Access Compliance Report

Public Rights-of-Way

Intersection ID: 53804	Main Street: NATHAN_DR	Cross Street: PITZER_DR	Location: S
ADA ID: 768BE11F46A5	Ramp Type: Perp	Initial Pass/Fail: Fail	Overall Compliance: No
			Severity Score: 26.25

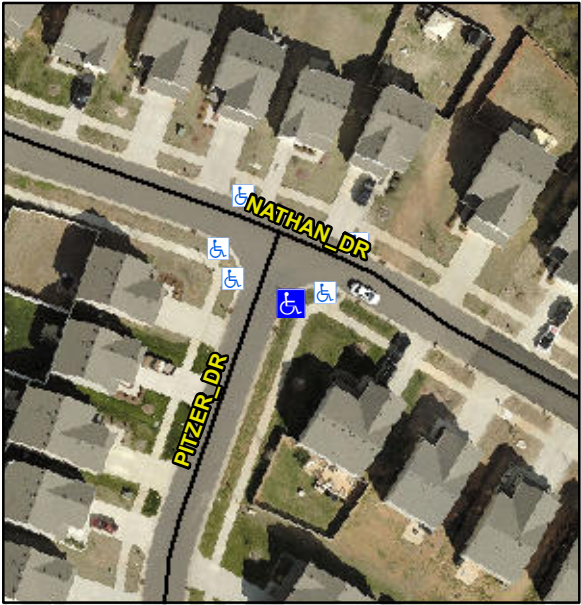
Codes/Mitigation Info/Possible Solution			Field Measurements/Component Compliance		
	Possible Solutions:		Compliance	Description	Data
	Remove & Replace Entire Ramp.		No	Ramp Length (in)	95.5
			Yes	Ramp Width (in)	59.0
			N/A	Flare Type LT	N/A
			N/A	Flare Slope LT (%)	N/A
			N/A	Flare Traversable LT?	N/A
			N/A	Landing Length (in)	N/A
			N/A	Landing Width (in)	N/A
			N/A	Landing Slope (%)	N/A
			N/A	Landing X Slope (%)	N/A
<p>Surveyor Notes:</p> <p>N/A</p> <p>PROW/ADA:</p> <p>Not Found, R304.2.2, R304.5.3</p>			N/A	Flare Type RT	N/A
			N/A	Flare Slope RT (%)	N/A
			N/A	Flare Traversable RT?	N/A
			N/A	DWS Provided?	N/A
			N/A	DWS Contrast?	N/A
			N/A	DWS Length (in)	N/A
			N/A	DWS Full Width?	N/A
			N/A	DWS Offset (in)	N/A
			N/A	Gutter Ponding?	Yes
			N/A	Gutter Lip Ht (in)	N/A
			No	Painted X Walk1?	N/A
			To NW	X Walk 1 Direction	N/A
			N/A	X Walk 1 Width (in)	N/A

4.4	X Walk 1 Slope (%)	N/A
			3.5	X Walk 1 X Slope (%)	N/A
			N/A	Ramp inside XWalk1?	N/A
			N/A	Road Slope (%)	N/A
			N/A	Road X Slope (%)	N/A
			N/A	Any Obstructions?	N/A
				Obstruction Type	N/A
Total Cost:			\$ 1850.00		
			N/A		N/A
			Yes	Surface Condition? (G/P)	Good
